Memorandum

Subject: BMA Goonyella Riverside and Broadmeadow Mine PRCP – Information Request Response EPML00853413

BMA Goonyella Riverside and Broadmeadow Mine PRCP Information Request Response

The purpose of this memo is to address the Information Request Notice relating to the Progressive Rehabilitation and Closure Plan (PRCP) for Goonyella Riverside and Broadmeadow Mine (GRM and BRM) – environmental authority (EA) EPML00853413.

Figure 5: Proposed Chute Locations

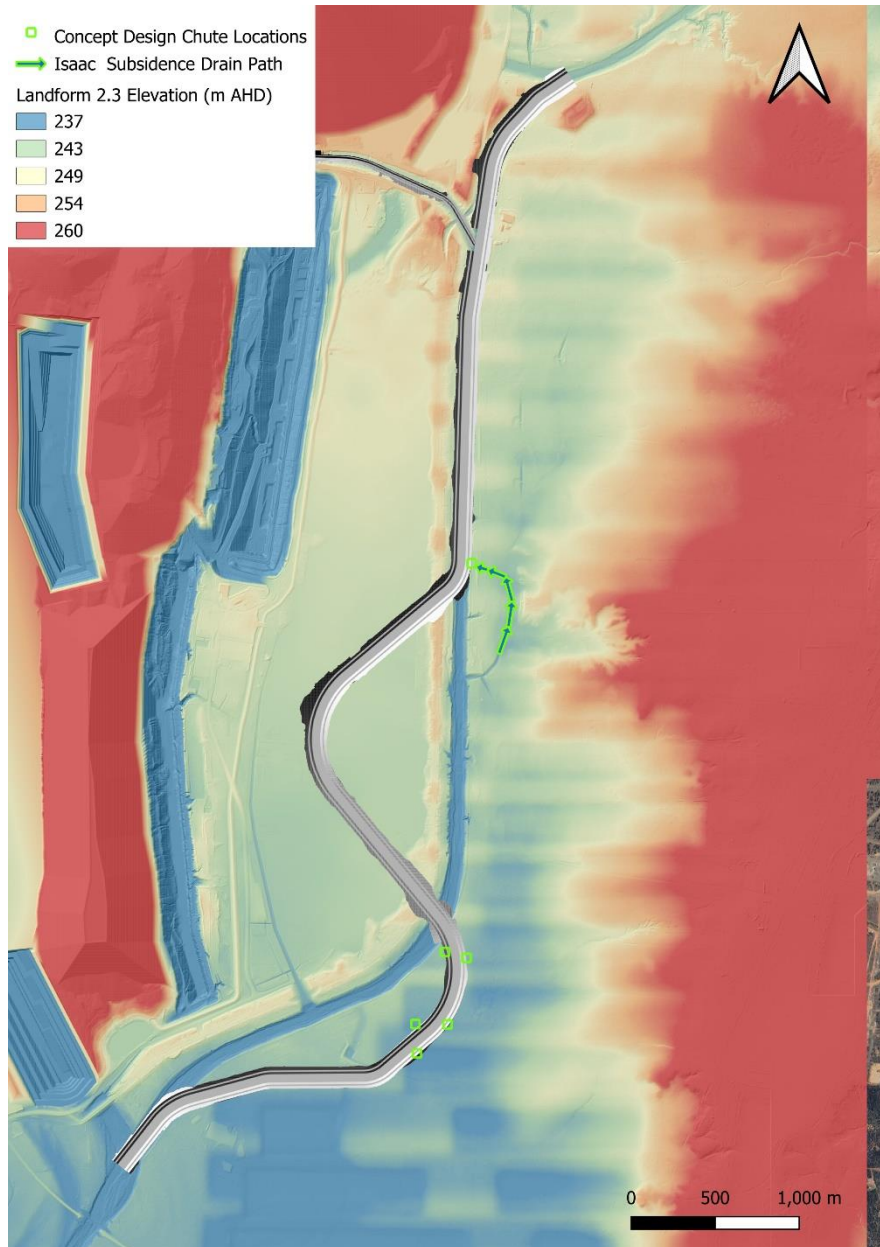
Item	PRCP Plan/ Schedule	Issue	Required Information
20	PRC plan section 6.4.1 Geotechnical study, Appendix P Geotechnical report. Appendix K, M, N, L Concept design reports for Isaac, Holding Paddock, Fisher and Eureka Creek	Stability of diversions considering subsidence impact The Isaac River Diversion (Stream Order 6) and Eureka Creek Diversion are located in areas affected by subsidence from Broadmeadow UG mining. Subsidence poses risks to achieving a stable post-mining land use (PMLU) due to: - Channel instability from deformation, erosion, and altered hydraulic connectivity. - Disruptions to sediment transport, increasing deposition and erosion risks. - Bank instability, reducing the ability to sustain riparian vegetation. Additional subsidence after mine flooding is identified as a potential concern. Also, report suggests that consolidation of caved rock after flooding may increase subsidence beyond initial estimates, but this effect does not seem to be included in the subsidence model.	Provide a revised PRC plan or relevant appendix which clarifies – a) How the PRC plan and PRCP schedule incorporates subsidence related assessments into the final diversion design, b) How the PRC plan satisfies EA Schedule J: Watercourse Subsidence, specifically: - demonstrate how the Subsidence Management Plan assesses subsidence impacts on the Isaac River and floodplain, defines mitigation measures, and incorporates structured monitoring and rehabilitation strategies. - explain how rehabilitation objectives, completion criteria, and schedules ensure that subsided areas achieve stability

Engeny acknowledges a reduction in stream power will be caused as a result of subsidence troughs along the riverbed. This ultimately results in a disruption to the sediment transport regime, causing sediment to deposit and leading to potential downstream channel widening. As described in Table 4-1 of the Goonyella Riverside and Broadmeadow Mine Subsidence Management Plan (Lucas, et al., 2015), This channel deepening and widening has both negative (bank erosion) and positive (habitat creation) impacts. Negative impacts can be mitigated through channel bed and bank protective measures initialled during monitoring periods. Adaptive methodologies to be utilised during monitoring are described in the Broadmeadow Subsidence Management Plan (BMA, 2023).

Disruptions to sediment transport as a result of subsidence, will only be temporary, relative to a closure scale. Boarder sediment transport impacts are discussed the Isaac River Cumulative Subsidence Impacts Assessment (IRCI), which investigated the impacts subsidence will have on sediment transport throughout the Isaac River (Crerar, et al., 2008). This study was later updated to include updated mining plans (Lucas & Crerar, 2013). This estimated that subsidence infilling will occur between 10 – 100 years following the completion of mining. These studies demonstrate that disruptions to sediment transport, as a result of subsidence, will not result in long-term instability of the Isaac River post closure as the riverbed will infill to a natural state.
